INFORMATION BULLETIN
CHANGES REQUIRED FOR BREAK-IN KEYING OF HT-37

089-002041

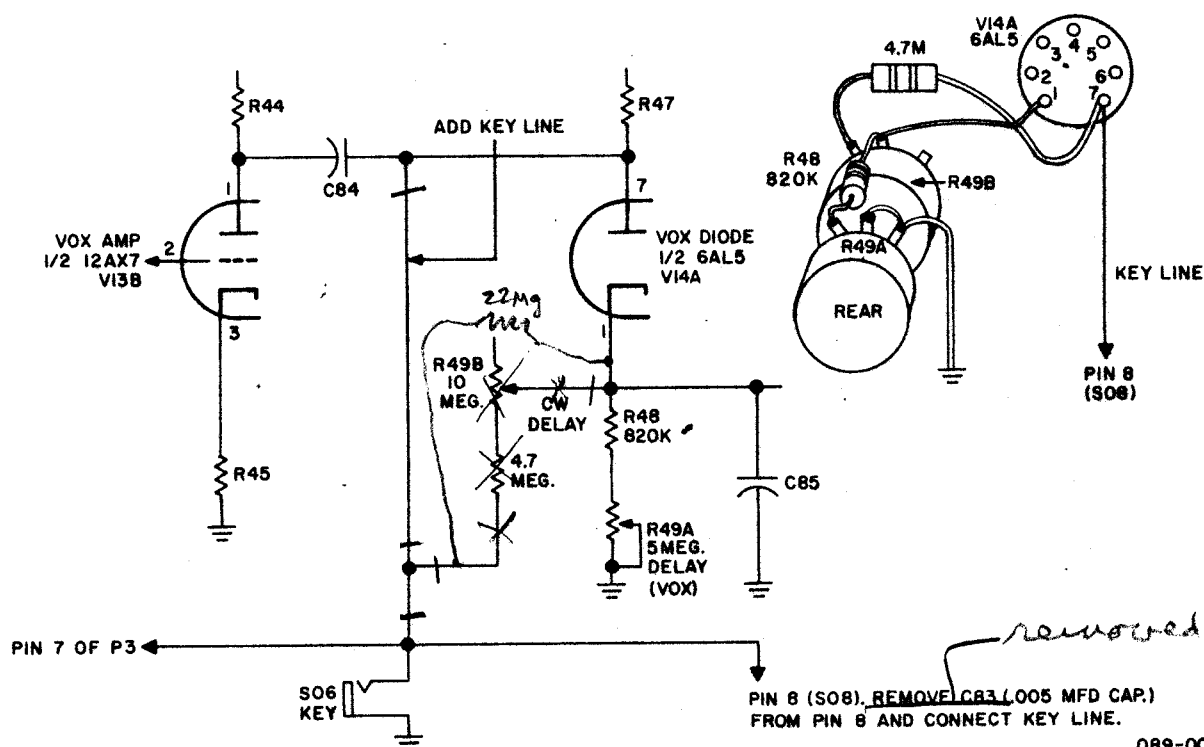
B. Remove single potentiometer R49 and install dual potentiometer R49A and add a 4.7 megohm 1/2 watt resistor as shown in the illustration above.

Adjustment for the VOX control (R49A, center shaft) is not affected by this modification.

Automatic break-in keying is accomplished by placing the OPERATION control in the "MOX" position, and turning the CW DELAY control (R49B, sleeve shaft) counterclockwise until the VOX relay de-energizes. With this accomplished, every time the key is closed, the VOX relay will energize, and transmission will begin starting with the first dot. This setting of the CW DELAY control affords the longest delay between the end of transmission and the reactivating of the receiver. For shorter delays turn the CW DELAY control further counterclockwise. To restore normal CW operation on "MOX" return the CW DELAY control to its maximum clockwise position.

The CW DELAY control adjustment need not be changed when switching to other manually operated modes of operation such as DSB or SSB. If normal manual CW operation is desired the CW DELAY control must be in its maximum clock wise position.
